AGENDA**Molalla Planning Commission**

6:30 PM, August 7, 2019

**Minutes of the Molalla Planning Commission
Molalla Adult Center
315 Kennel Ave., Molalla, OR 97038
December 5, 2018**

DATE: **A01**

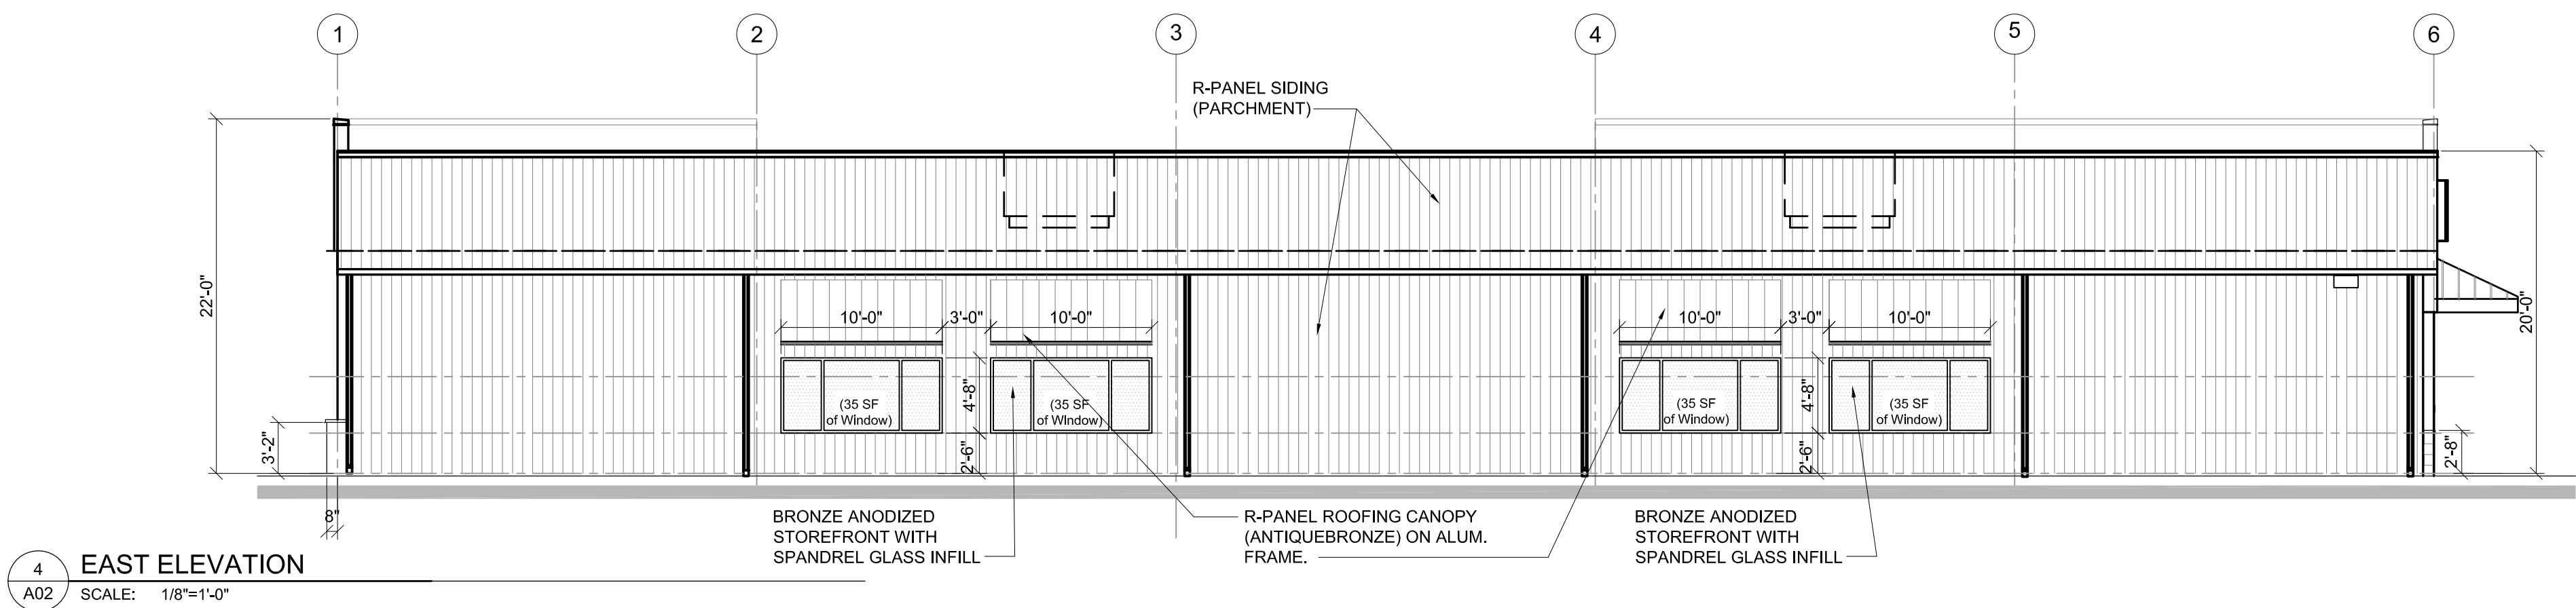
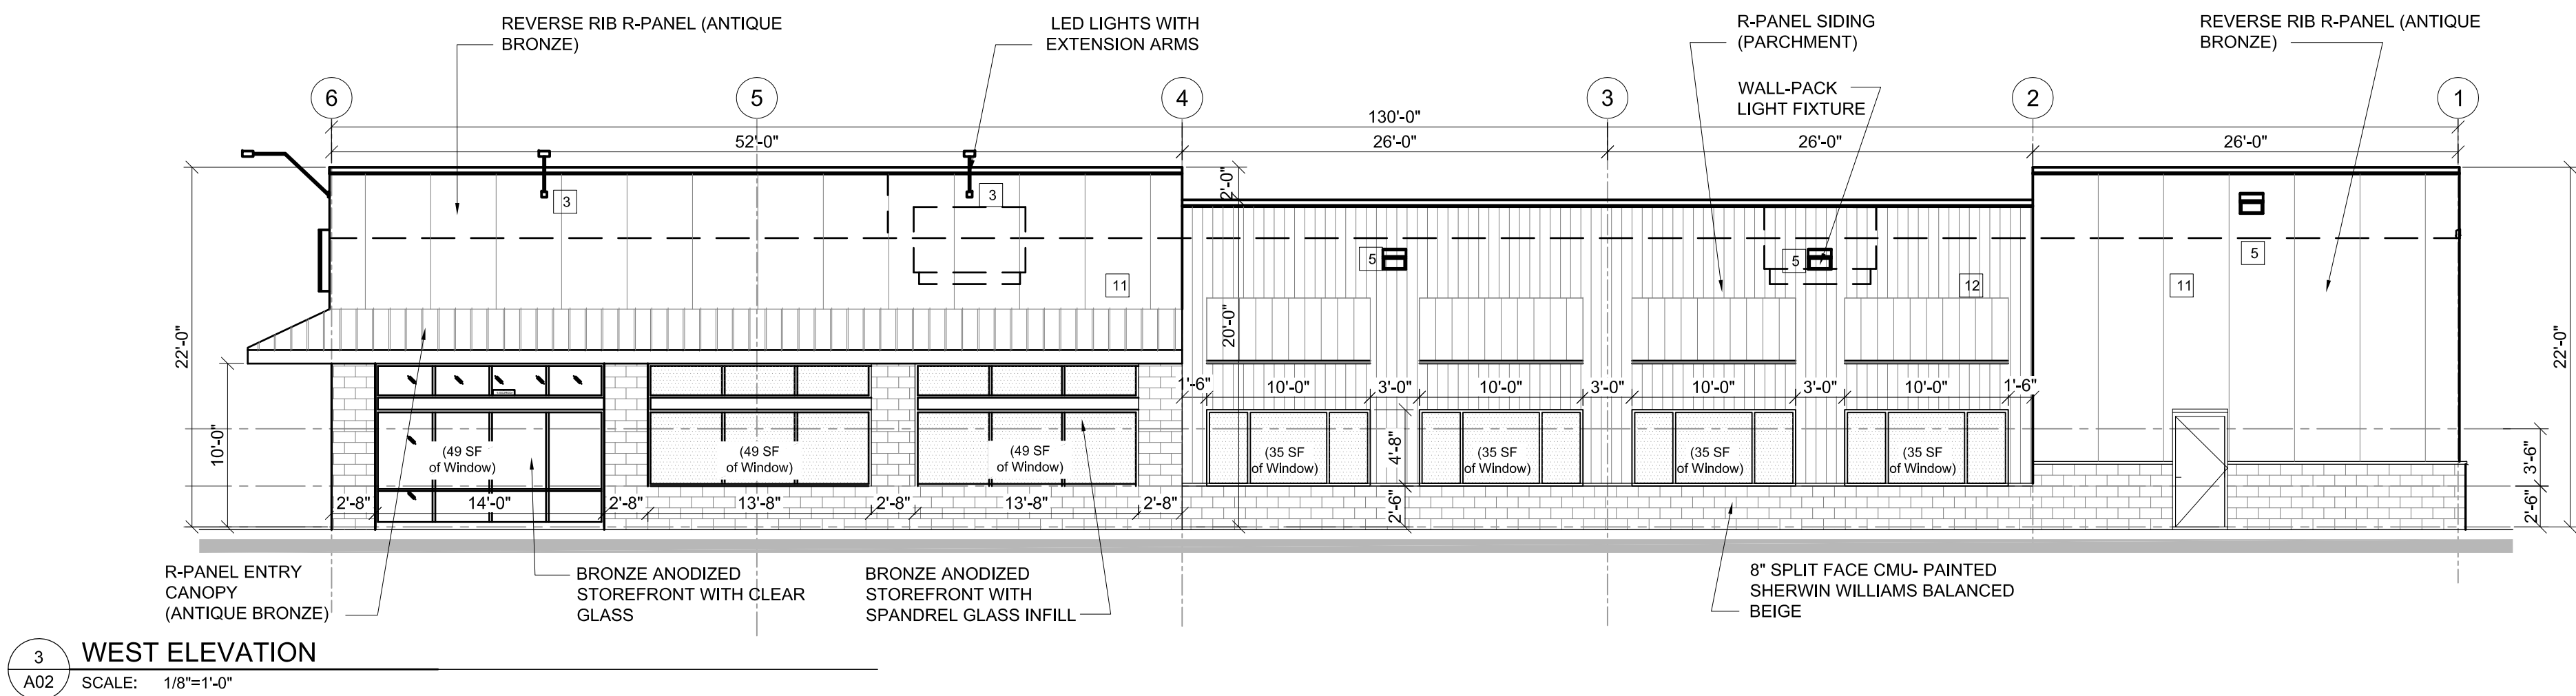
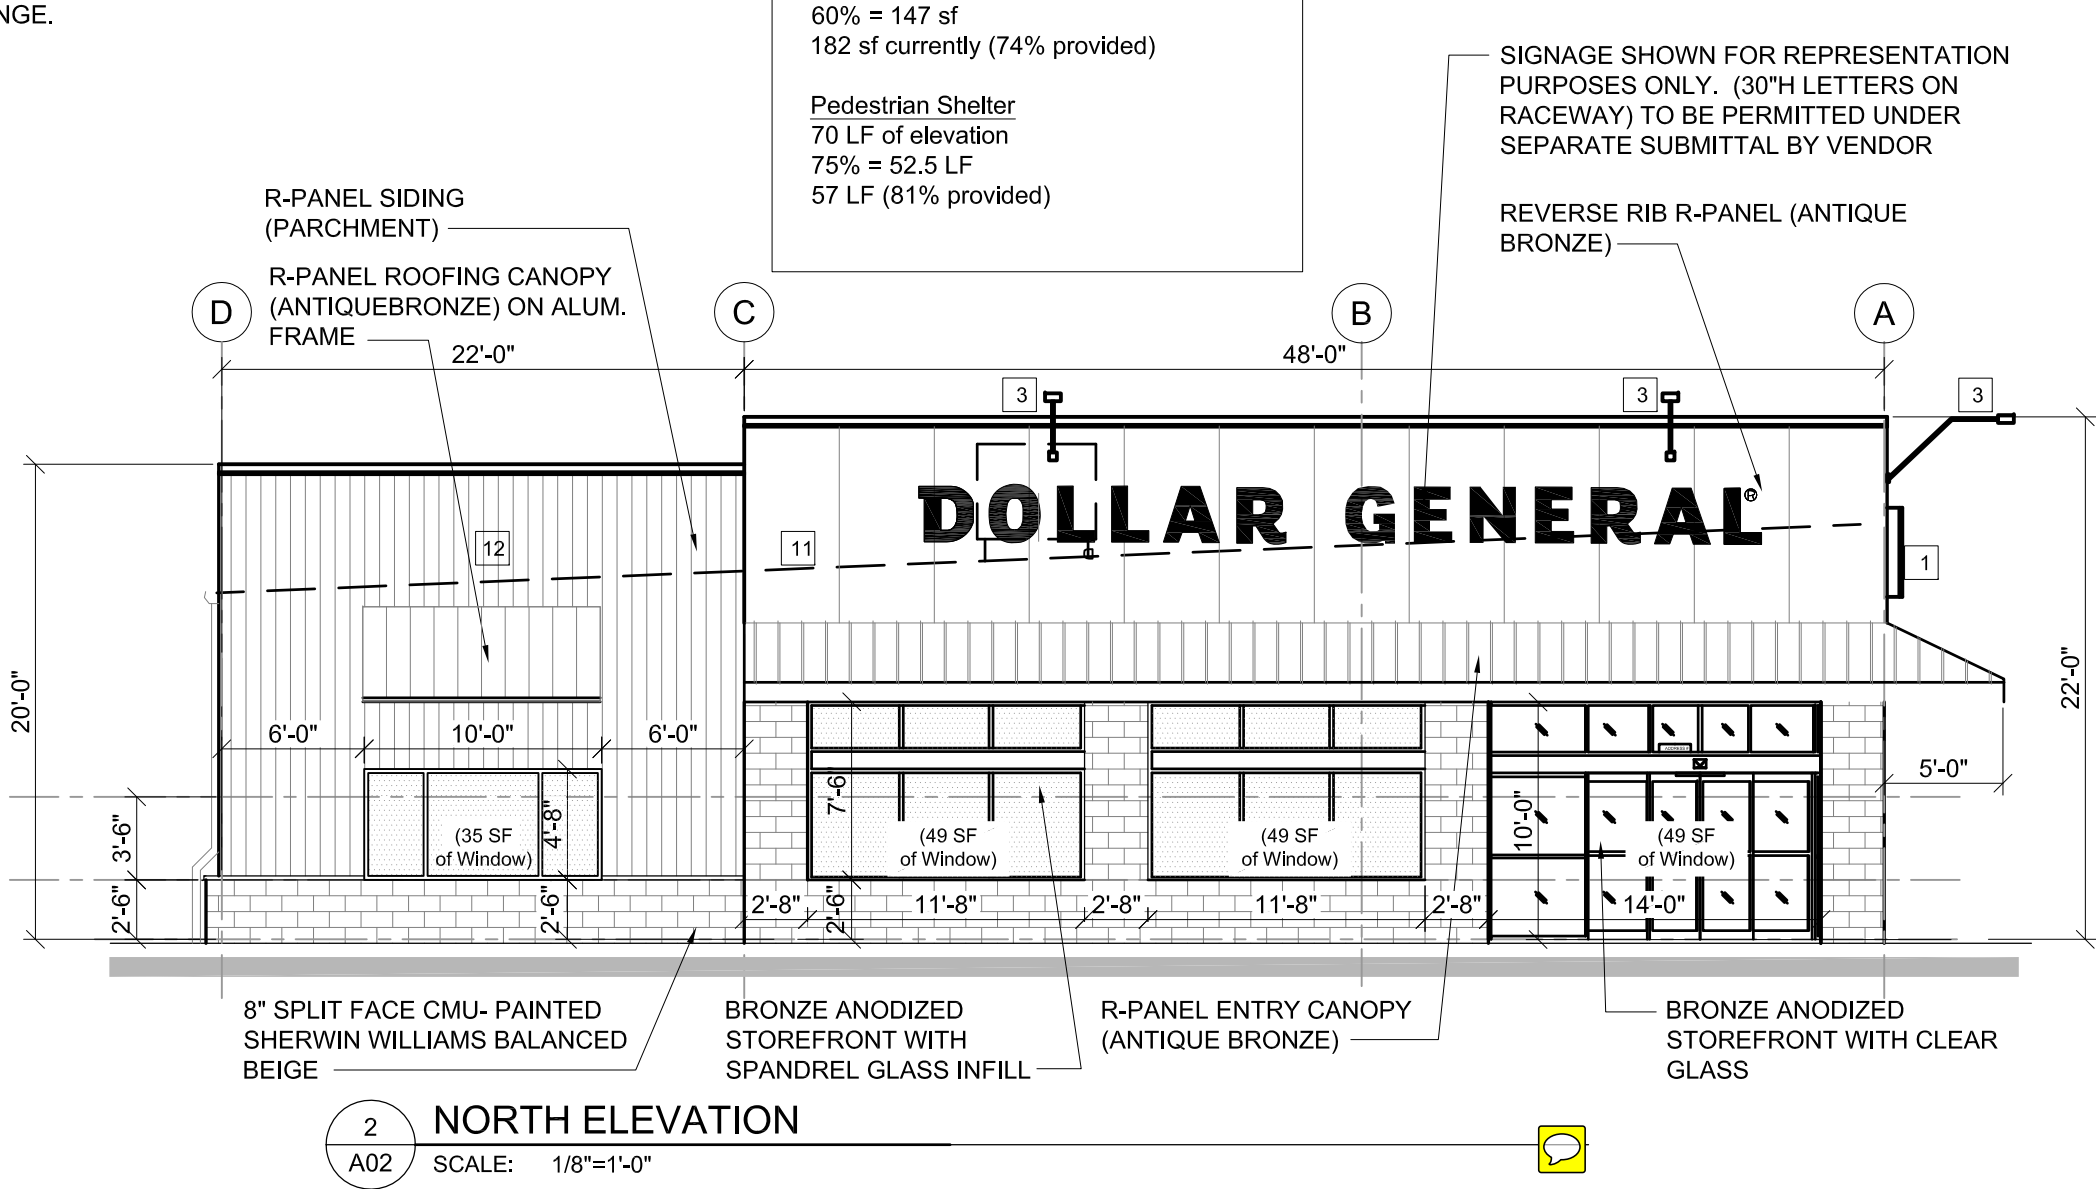
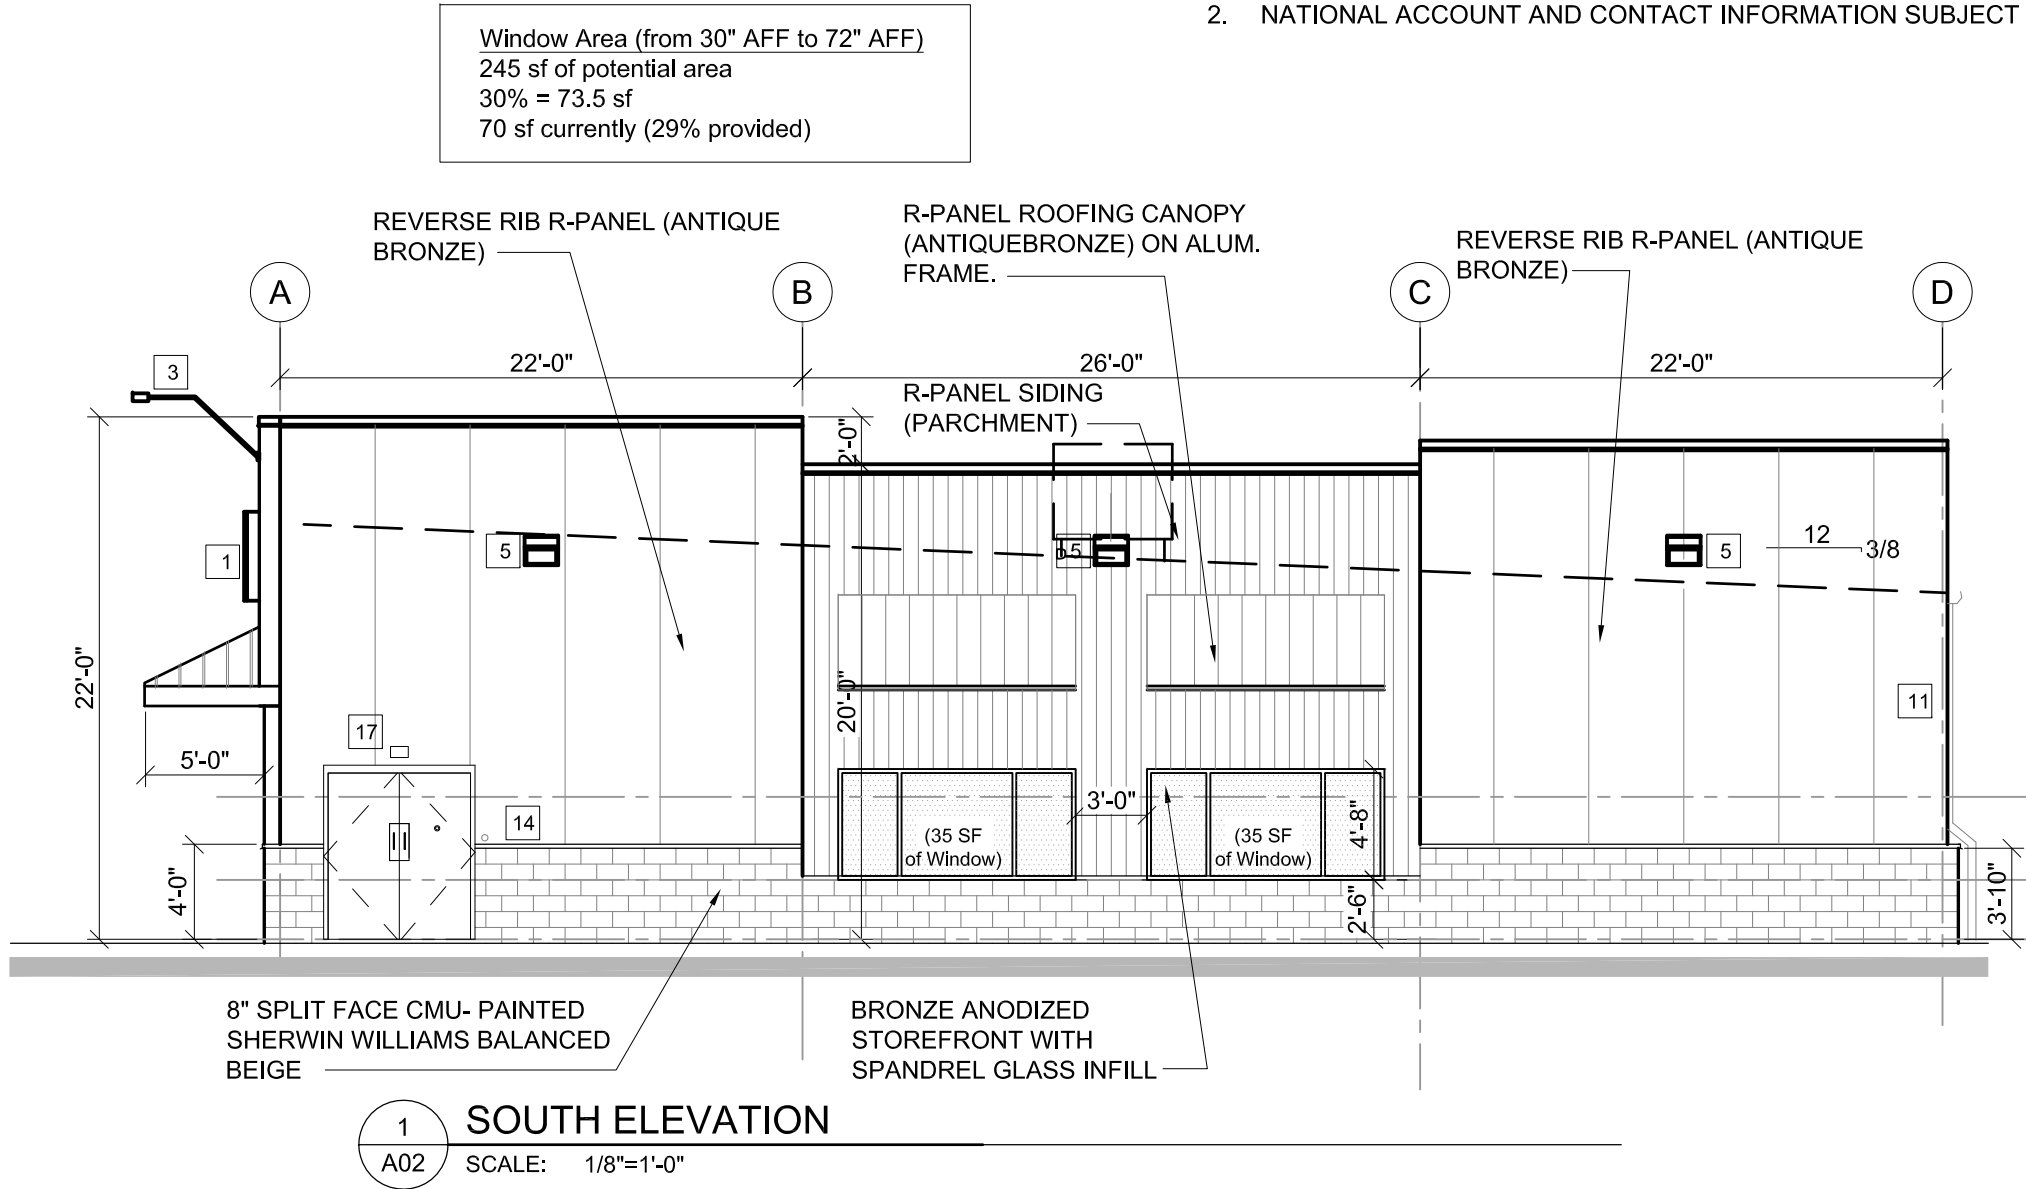
- a. Revise Sheet A02 to wrap the brick façade from the north and south elevations to the eastern elevation, extending across the entirety of the eastern elevation.
17-3.2.040 (E)(2)
- b. Revise Sheet A02 to show the dimensions of the parapet screening or location of the HVAC system on the east, west, and southern elevation plans.
17-3.2.040 (G)(2)
- c. Revise Sheet La.01 to identify all pedestrian amenities on the submitted landscaping site plan, to justify a 10-foot "build to" from the OR-211 property line and the 94-foot "build to" setback from the Leroy Avenue property line. Sheet La.01 shows landscaping in the "pedestrian amenity area, appearing to discourage

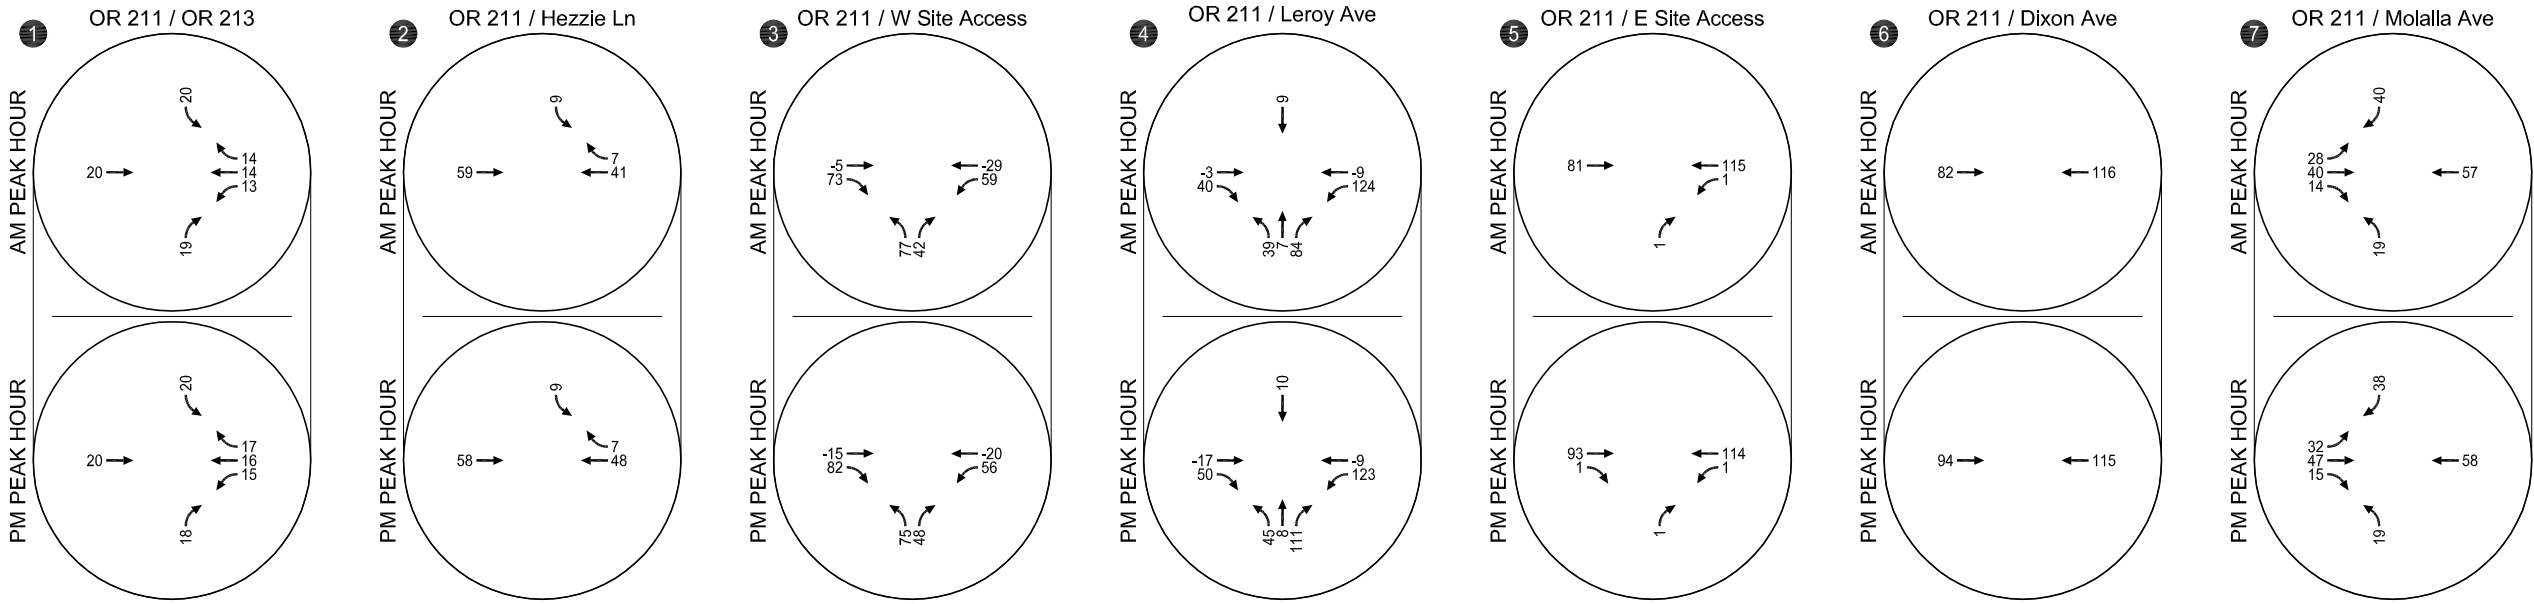
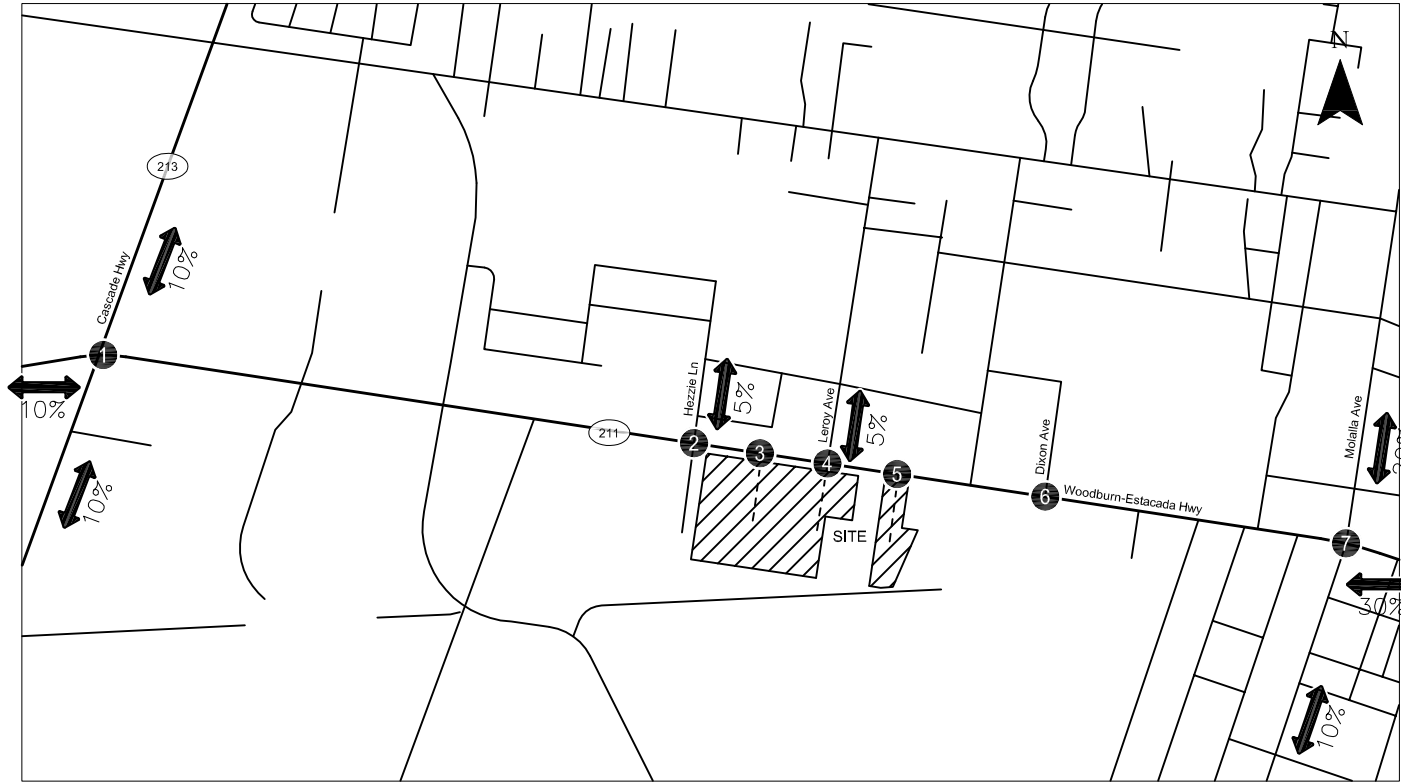
- VI. Figure 5 and 7 of the TIA do not include the reported v/c for OR211/Molalla Avenue intersection (Intersection 7).
